AGENDA
ZONING BOARD OF ADJUSTMENT
REGULAR MEETING
4:00 P.M., Wednesday, June 6, 2018
City Council Chambers, 2nd Floor of City Hall
823, Rosenberg, Galveston, Texas

STAFF REPORT

18Z-011

Re: **ZBA Variance Application**
Hilton Garden Inn – Seawall Blvd and 77th St.
7627 Stewart Rd.

A0.01

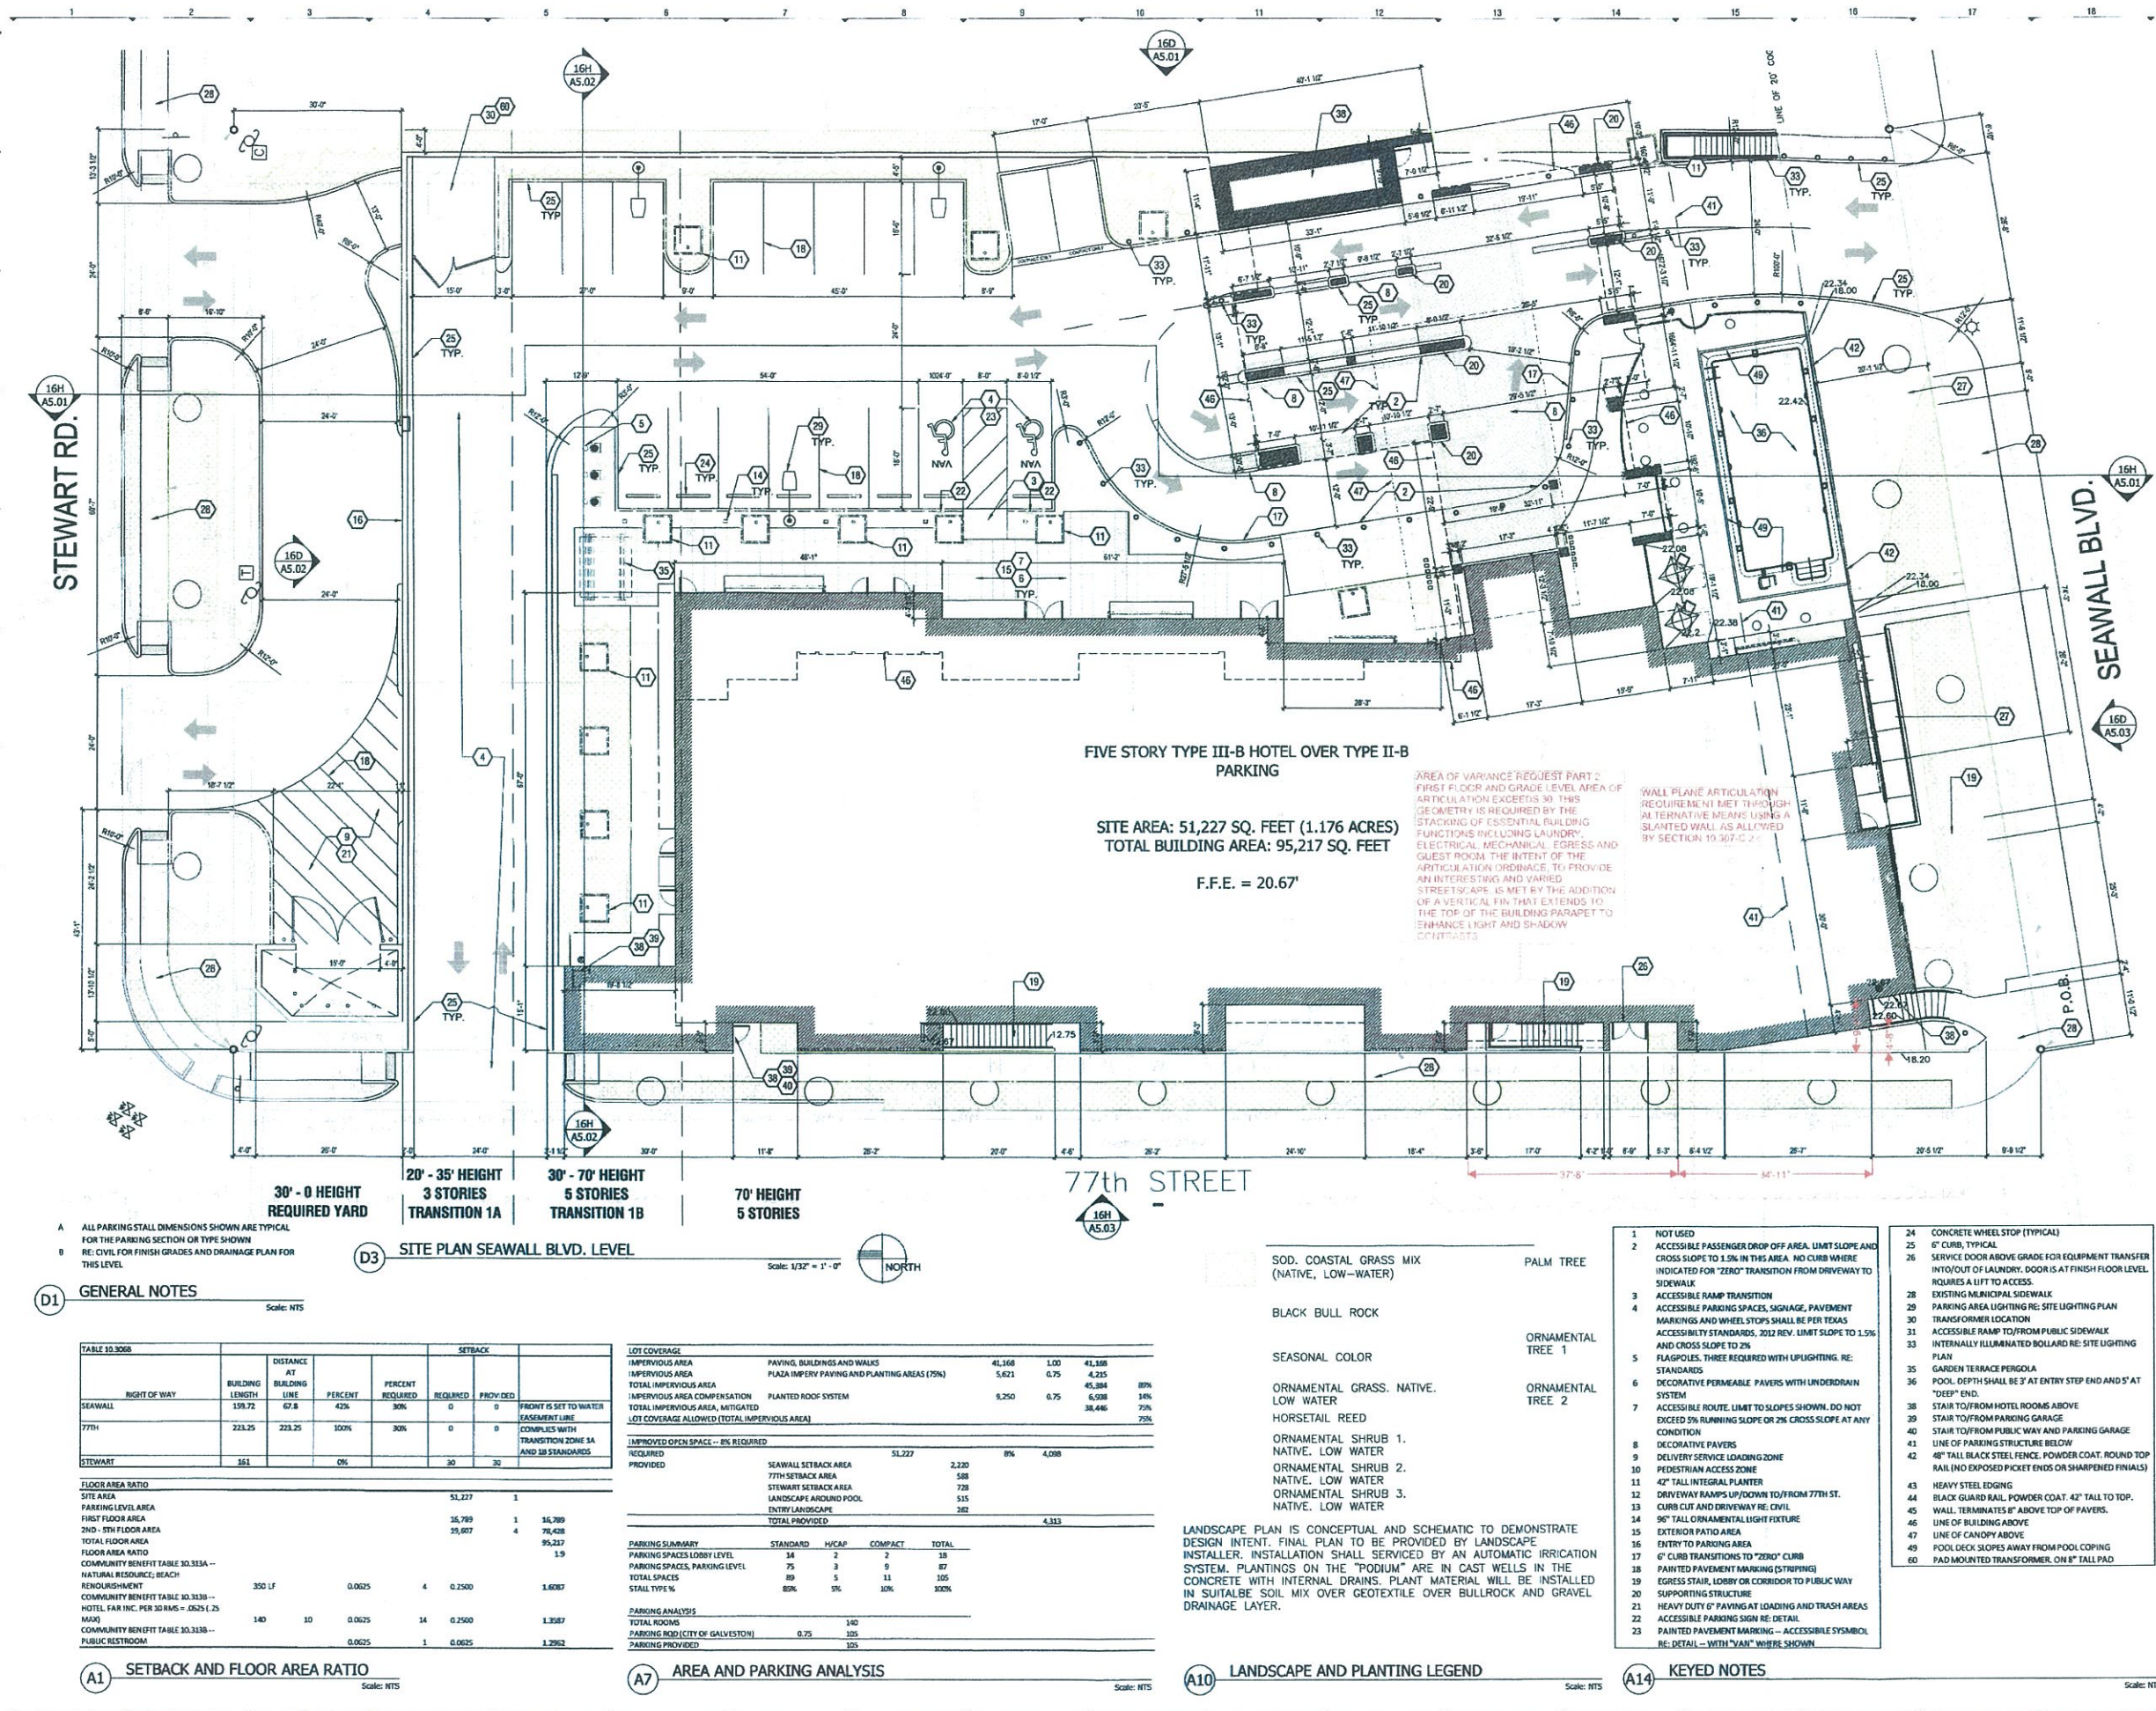
The applicant is requesting a variance from Wall Plane Articulation in two places on the west side of the proposed hotel. The two places that will not meet the Building wall Length maximum of 30-feet are side by side with a maximum wall space of 37-feet, 8-inches. Reference Exhibit B page A0.01.

Wall Plane Articulation (Building Wall Length) – From 30-feet to 37-feet, 8- inches.

A5.02

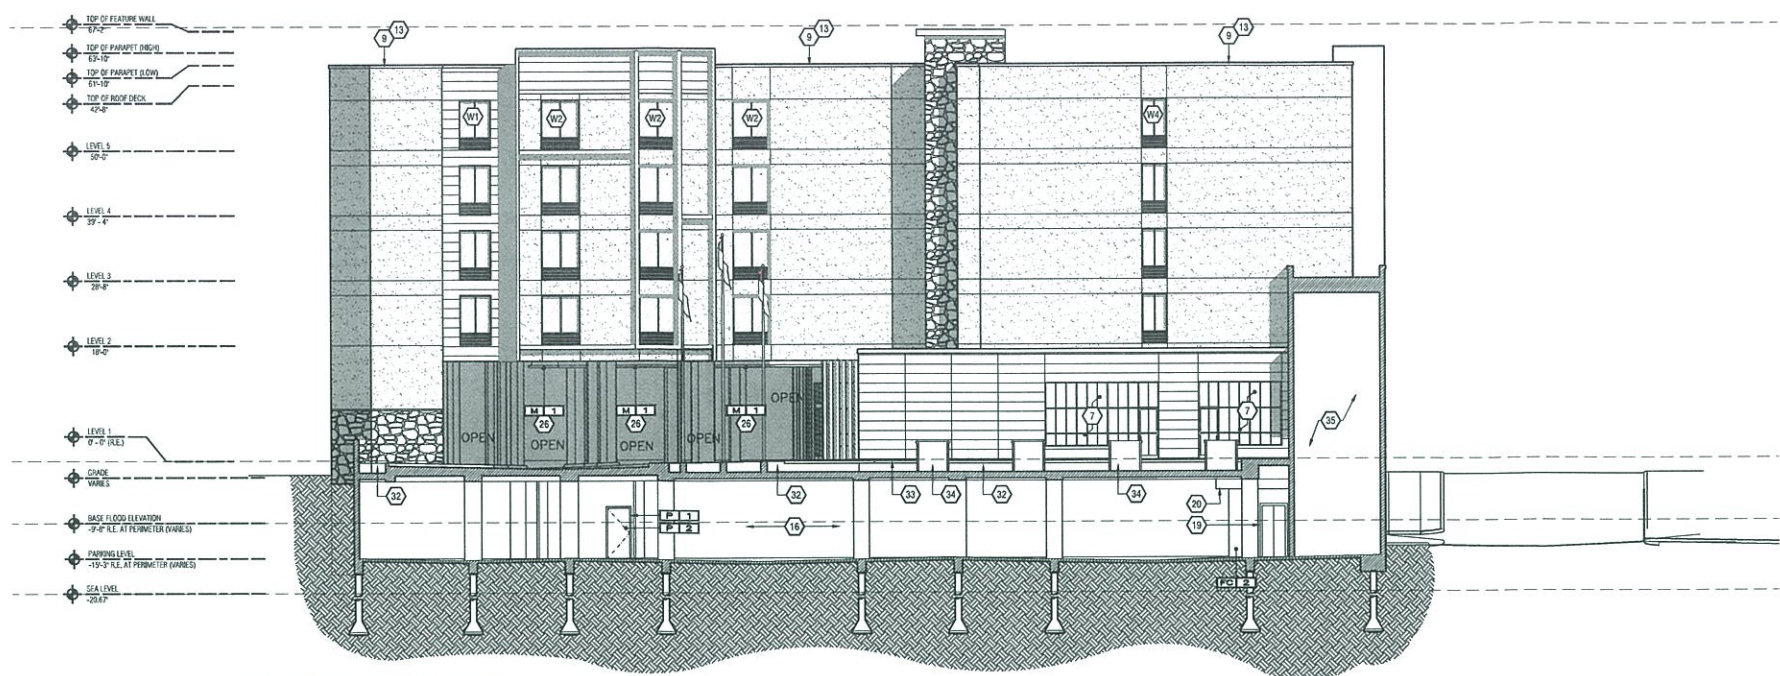
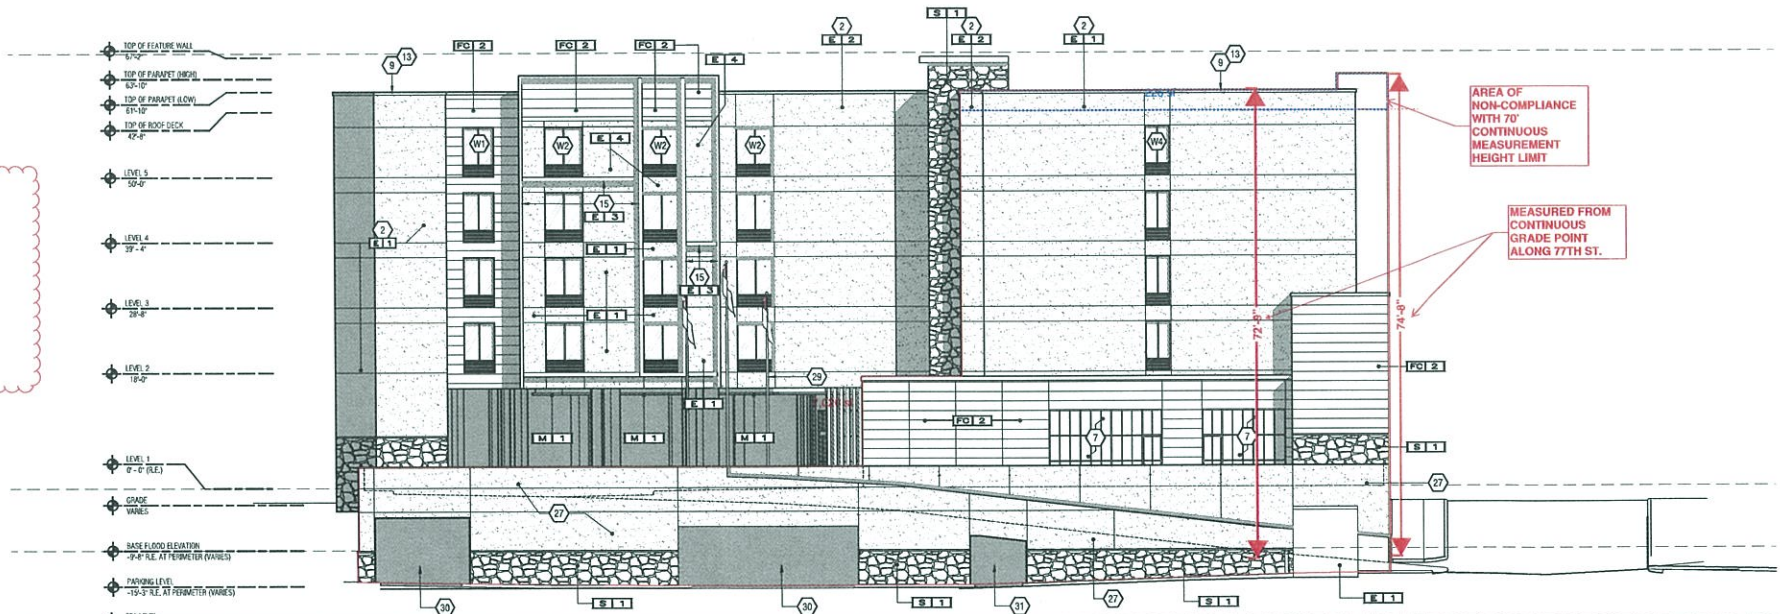
The applicant is requesting a variance from height along the north and west sides of the proposed Hotel shown in Exhibit B pages A5.02 and A5.03. The red arrows indicate the height in specific areas along those sides of the hotel due to the grade change. The highest point of the building is proposed to be 74-feet, 8-inches from grade.

Height - From 70-feet to 74-feet 8-inches

CONTINUOUS HEIGHT COMPLIANCE ANALYSIS:

TOTAL AREA OF THIS ELEVATION (IMPACTED PLANES) = 7,020 SQ. FT.

AREA EXCEEDING 70 CONTINUOUS MEASUREMENT LIMIT = 226 SQ. FT.

COMPLIANT AREA = 96.8%

NON COMPLIANT AREA = 3.2%

1. **Variance Request One. Continuous Measurement Standard, Section 10.303-I.** This standard states that the maximum height for the building shall be measured continuously from existing or finished grade. We are requesting a variance from this standard along parts of the West (77th St.) elevation and parts of the North (Stewart) elevation. Specifically, referring to drawing sheet A5.03, we propose that 246 square feet of the total 16,249 square feet-- 1.5% of the West elevation--be allowed to exceed the continuous measurement standard by less than four feet at its worst condition. Additionally, referring to drawing sheet A5.02, we have 226 square

feet of the total 7,020 square foot far North elevation that exceeds this standard (3.2%). We believe that the other elevations comply with the standards as designed.
